Submissions

To: dasubmissions
Subject: Submission - D/2024/122 - 141-155 Commonwealth Street SURRY HILLS NSW 2010 - Attention Christopher Ashworth

**PAN-409601 DEMOLITION AND CONSTRUCTION OF PART 5, PART 6 COMMERCIAL BUILDING.
141-155 COMMONWEALTH STREET, SURRY HILLS**

Figure 3: Extract from West Elevation showing proposed uses in proximity to SP 57988
 (Source: DA plans – West Elevation; annotated by DC)

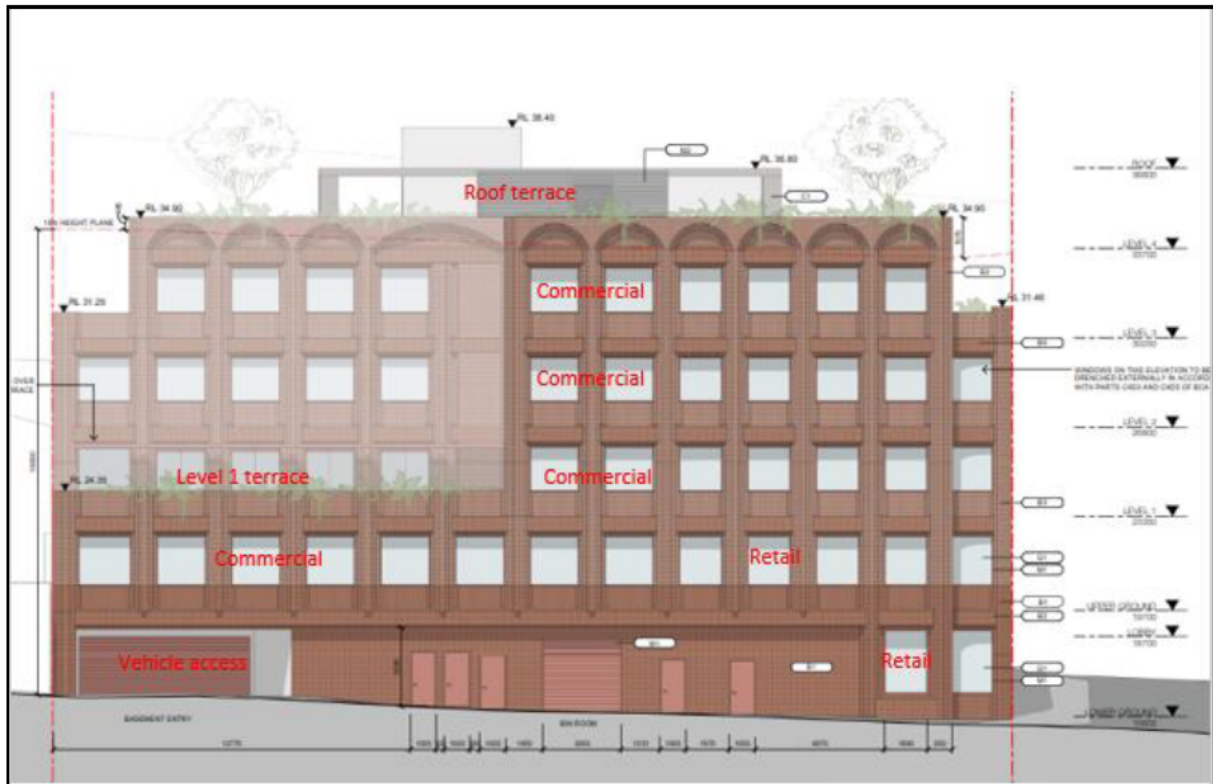
The distribution of uses facing Beauchamp Lane and SP 57988 is shown in **Figure 3** below.

As noted above, the western elevation of the proposed building incorporates extensive clear glazing to the commercial and retail floor space which is separated from our client's building by only some 4.5m across Beauchamp Lane (see **Figure 3**). This degree of separation is well below the generally accepted 12m minimum separation between habitable rooms and is considered unacceptable.

The extensive clear glazing proposed would result in the opportunity for direct overlooking of the internal and external spaces of the units at the lower 3 levels of our client's building (see **Figure 1** above) and would have a significant adverse impact on their privacy and amenity generally. Concerns are also raised regarding light spill from the proposed floors during the night-time period.

Figure 4: Extract from Level 04 plan showing roof terrace

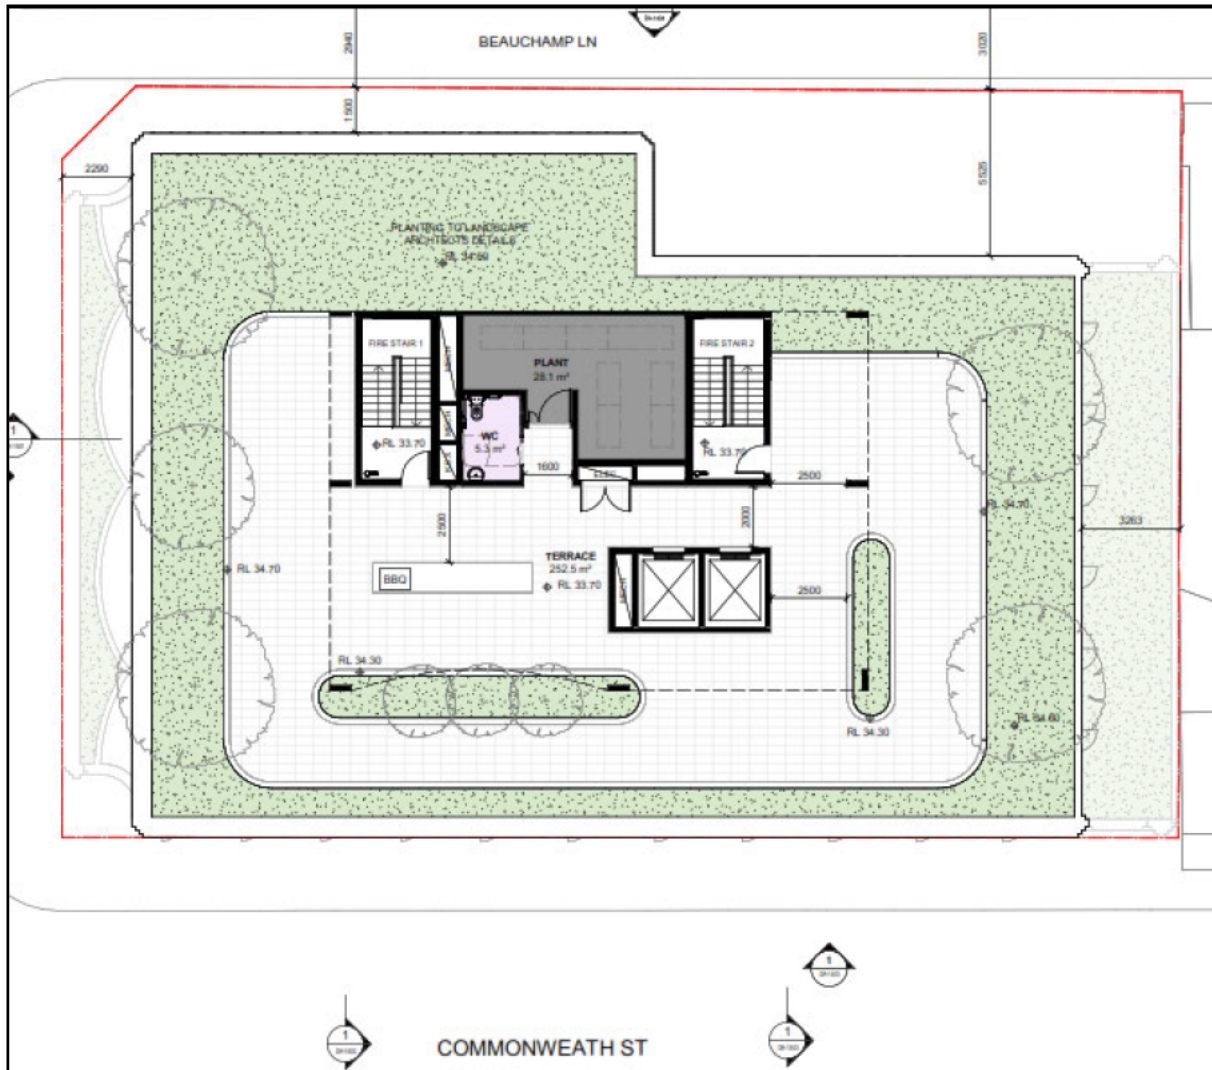
As noted above, the proposal includes a roof terrace (see **Figure 4**). The roof terrace has an area of 252sqm. Landscaping/non-trafficable space surrounds the roof terrace area to all boundaries.

No Plan of Management is submitted for the use of the roof terrace.

The design of the roof terrace is open to the west above the level of landscaped/non-trafficable planters and, taking into account overshadowing and height considerations, there is limited opportunity for additional shielding to our client's property to the west to prevent noise impacts. Therefore, the assessment and management of the use of the roof terraces is very important to ensure that the DA impacts are acceptable.

In addition, no Plan of Management has been lodged for the operation of the roof terrace setting out the proposed controls and operational matters. While the DA refers to signage, as there are a likely to be a range of tenants in the building and the roof terrace is likely to be an attractive, popular space, a Plan of Management is needed to ensure that access is controlled/appropriately shared between tenants and to ensure compliance with the relevant assumptions/conditions.

- A Plan of Management should be provided for the use of the rooftop terrace, including the controls proposed in the DA submission, together with additional/revised controls, including a restriction on the maximum capacity of the space and prohibition on any amplified music (whether background or not);

Figure 5: Extract from Design Report showing Solar Access Analysis

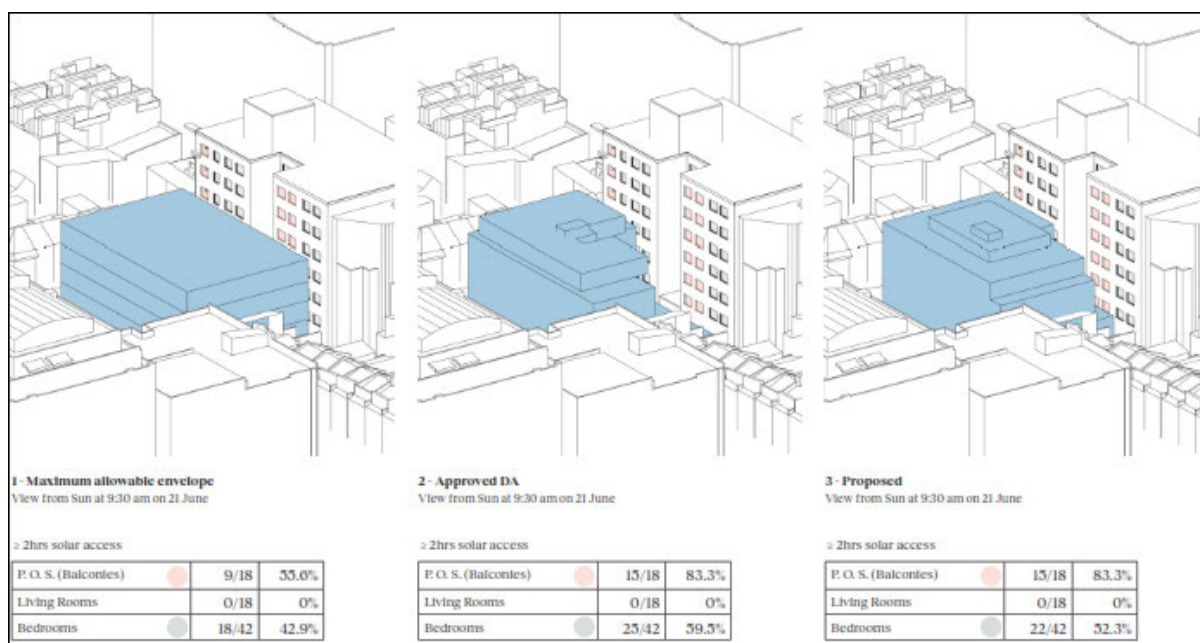
The DA SEE notes that the building form has been designed to maintain solar access to SP 57988 generally in accordance with DA 2017/1283 (see **Figure 5** below), including a 1.5m setback from laneway frontage at all levels and the step back (and terrace) at Level 1. The diagrams and table below show that the overshadowing impact on private open space in SP 57988 is the same as the 2017 DA (at 83.3%) but there is a greater impact on bedrooms with only 52.3% receiving 2 hours sunlight at 9.30am at midwinter, compared with 59.5% for the 2017 DA (a reduction of some 7%).

- The plans should be amended so that the proposed development will not give rise to any additional loss of solar access to east-facing units in our clients' building compared with the previously approved development on the site;

Figure 4 – Overlooking Diagram

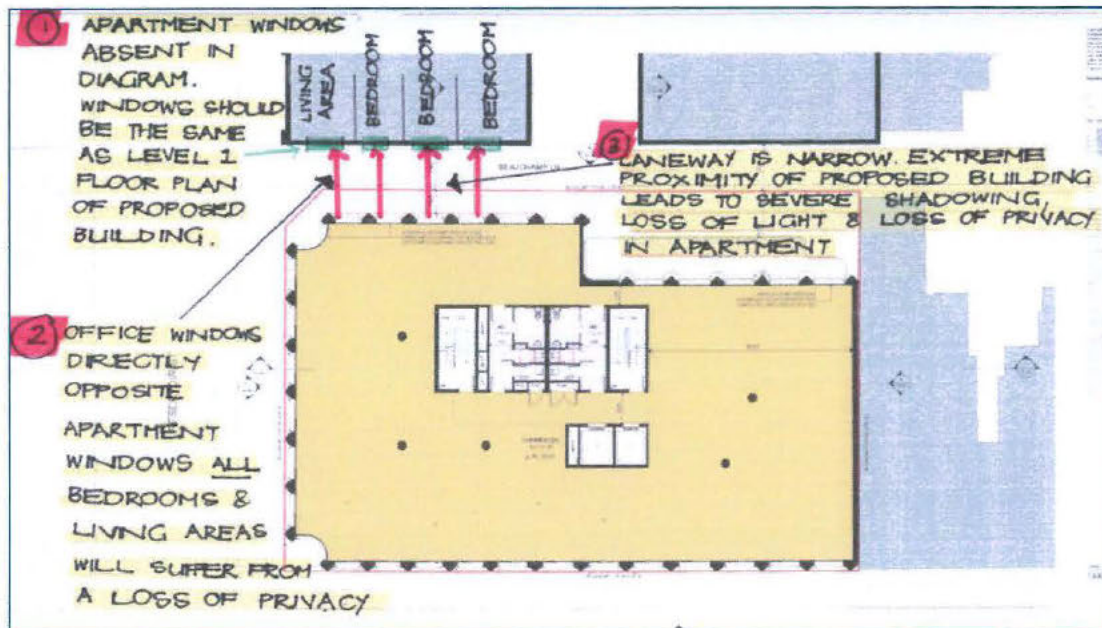
Windows along the western proposed under DA/2024/122 will allow for direct, unobstructed and close views into the principle private open space, and primary habitable living areas of [REDACTED] 74-80 Reservoir Street. Figures 4 and 5 show the expected views from the proposed westerly windows, straight into the primary living space and private bedrooms of the residential unit at [REDACTED] 74-80 Reservoir Street, resulting in a substantial and unacceptable visual privacy breach. Figures 8 – 11 show the living room and bedroom windows at present.

Figure 6 – Windows of concern along the proposed western elevation

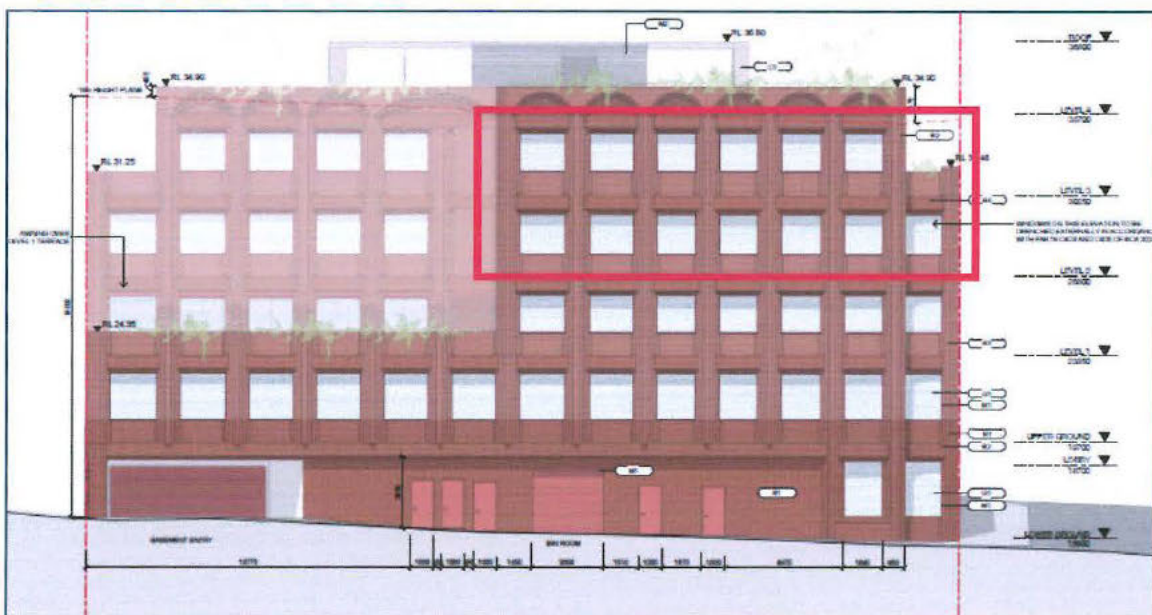
A suitable solution to mitigate the issues raised in this letter includes deleting the windows marked in figure 6 and setting the upper floors back as marked in figure 12.

In accordance with *Meriton v Sydney City Council [2004] NSWLEC 313*, a more considerate design as detailed later in this submission would assist to reasonably mitigate overlooking concerns between the two properties. **Deleting the windows marked in figure 6 and setting the upper floors back as marked in figure 12 will assist to overcome this.** Without the changes proposed in the Recommendations of this letter, the development cannot be supported in its current form.

- c) **Action:** Delete all windows shown in figure 6.
Outcome: This will mitigate views between the proposed commercial premises and the private areas of Unit [REDACTED] 74-80 Reservoir Street. The open plan nature of the proposed commercial allows the space to still receive sunlight and daylight through other openings.

Figure 7 – External windows of [REDACTED] 74-80 Reservoir Street (Corona Projects, 2024)

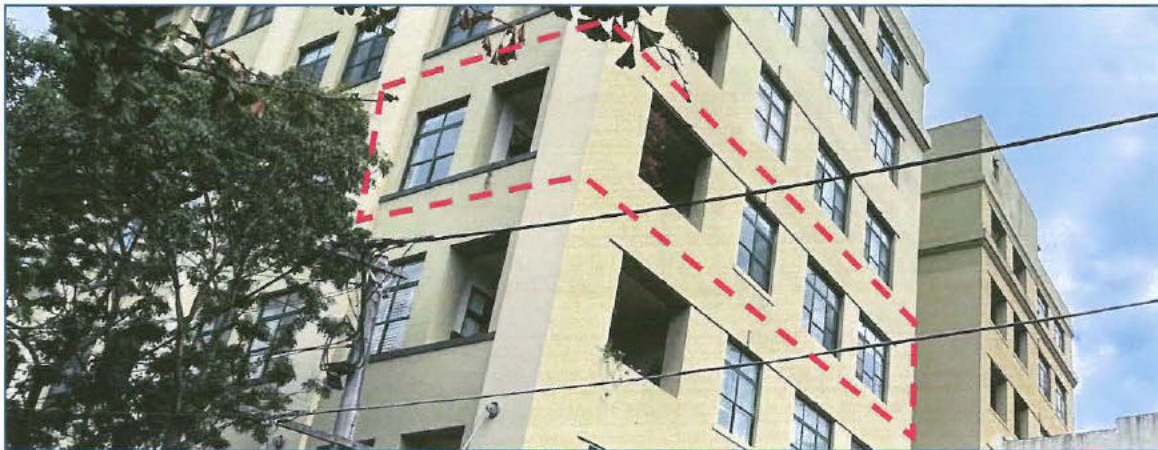
At present the private open space (balcony), living area and all bedrooms of [REDACTED] 74-80 Reservoir Street receives pleasant sunlight throughout the morning and midday throughout the year, reducing the reliance of non-renewable energy sources for the home. Refer to figures 8 – 11 for pictures of the windows of these spaces. Figure 7 shows the outside of these windows.

Whilst the applicant has failed to submit shadow diagrams depicting the impact of overshadowing on neighbouring sites, the works proposed under DA/2024/122 will undoubtedly substantially decrease the amount of sunlight received by [REDACTED] 74-80 Reservoir Street and other east-facing units, resulting in a non-compliance with the applicable solar access controls under Part 4.2.31 of the SDCP 2012 which requires:

- b) **Action:** Prepare Shadow Diagrams to show the overshadowing impact on Unit [REDACTED] 74-80 Reservoir Street. The Diagrams should be prepared hourly between 8am – 4pm on the Winter Solstice, Spring Equinox and Autumn Equinox. They should be prepared in both plan and elevational format.
Outcome: This will allow for an accurate understanding of shadow impact. No reduction of solar access to the balcony, living room or bedrooms at Unit [REDACTED] 74-80 Reservoir Street can be accepted.

Figure 12 – Recommendations (c) and (d) as viewed along the southern elevation.

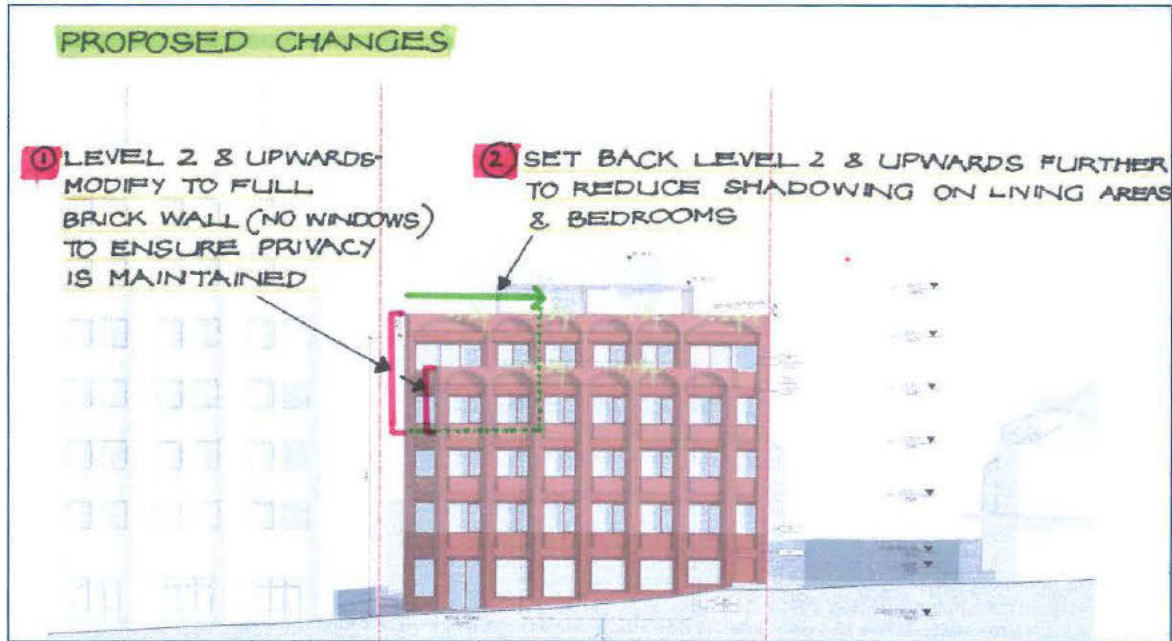
marked in figure 6 and setting the upper floors back as marked in figure 12 will assist to overcome this.

Deleting the windows marked in figure 6 and setting the upper floors back as marked in figure 12 will assist to overcome this.

- d) **Action:** Increase the western setback of the top three floors under DA/2024/122 as shown in figure 12.
Outcome: This will reduce the overshadowing and visual bulk impact produced by DA/2024/122.
